Elm, High, and Chatham Street Reconstruction Williamsburg, Iowa ADDENDUM #1

HR Green, Inc. Project No. 2402682

ADDENDUM NO.1

January 17, 2025

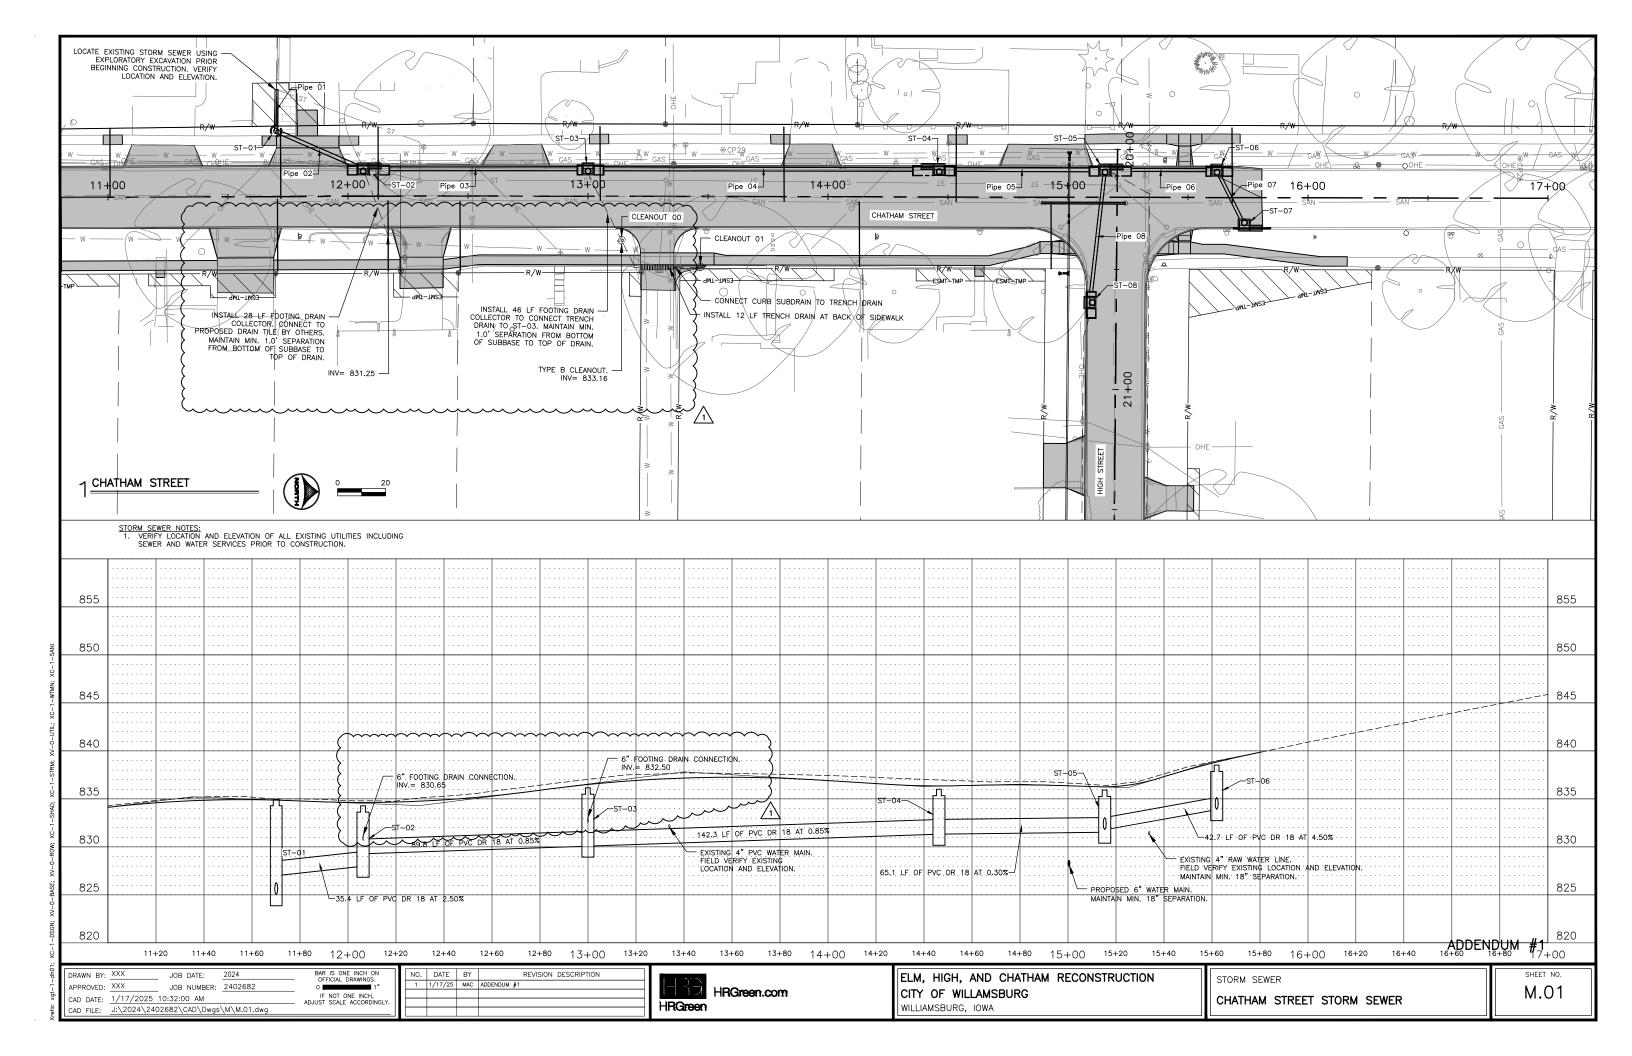
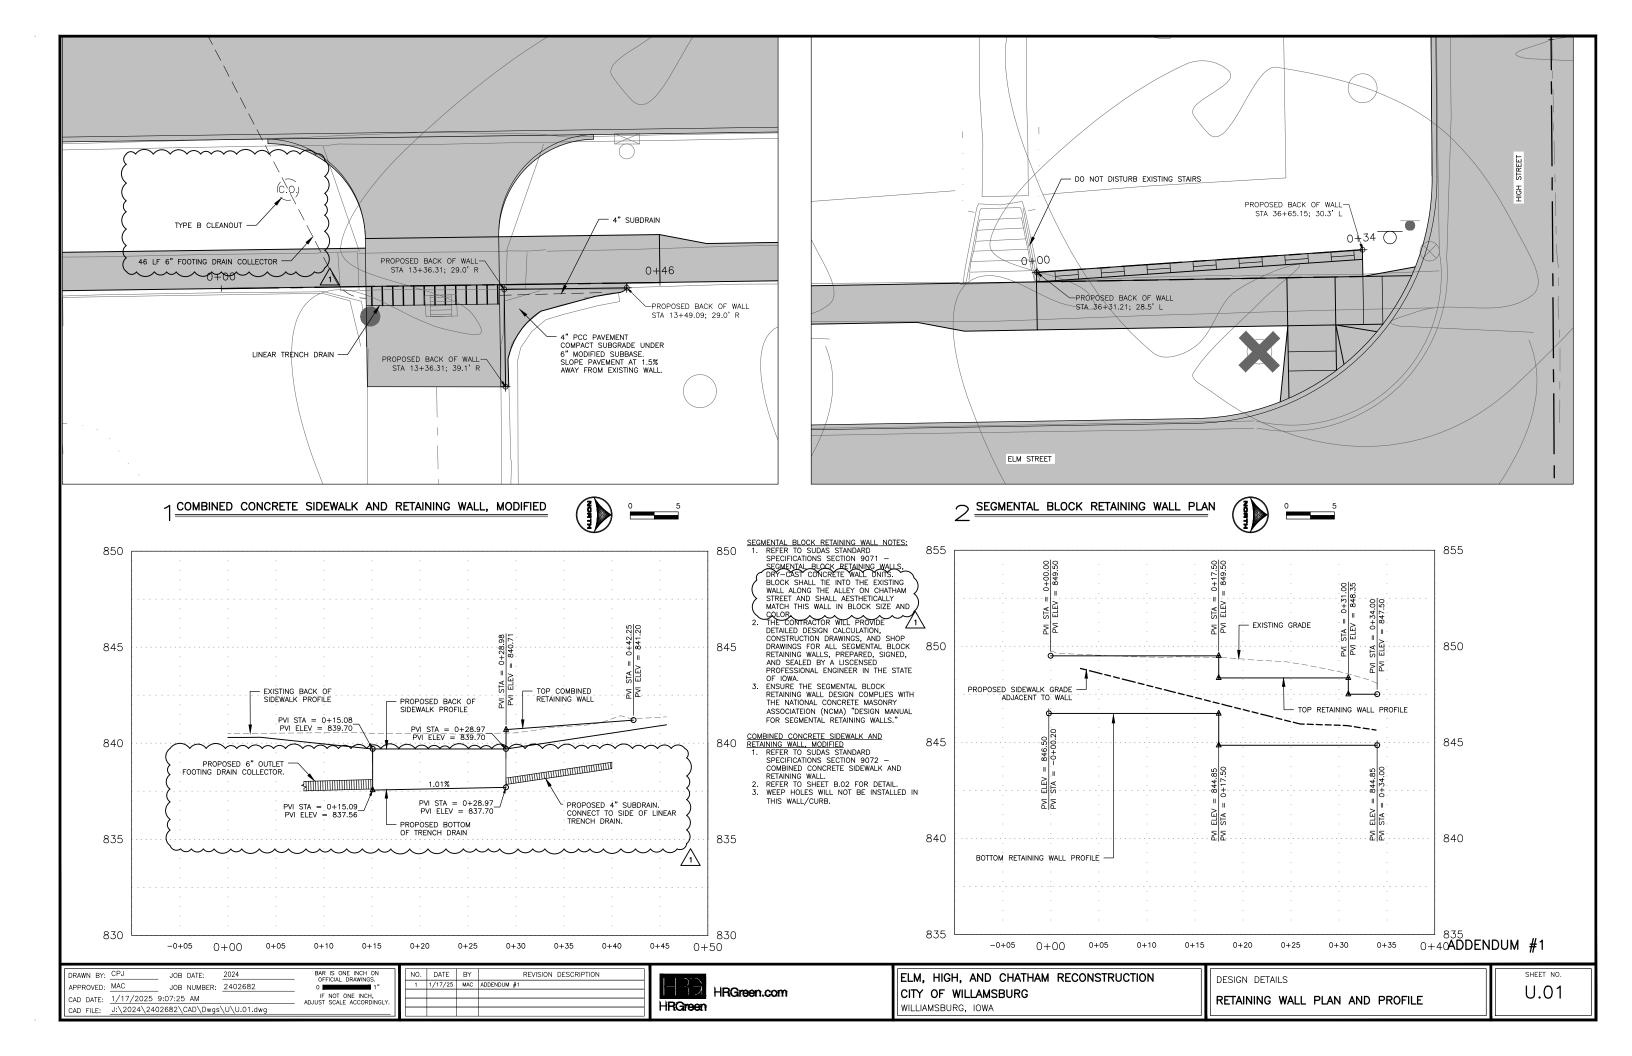
- a. **REVISE** Storm Sewer Table 104-5B, P-06 and P-20 Pipe Diameter from 15 to 16.
- b. **REVISE** Storm Sewer Table 104-5B, 15" SDR 26 to 15" HDPE and 18" SDR 26 to 18" HDPE.
- c. **REVISE** Storm Sewer Table 104-5B, 15" DR 18 to 16" DR 18.
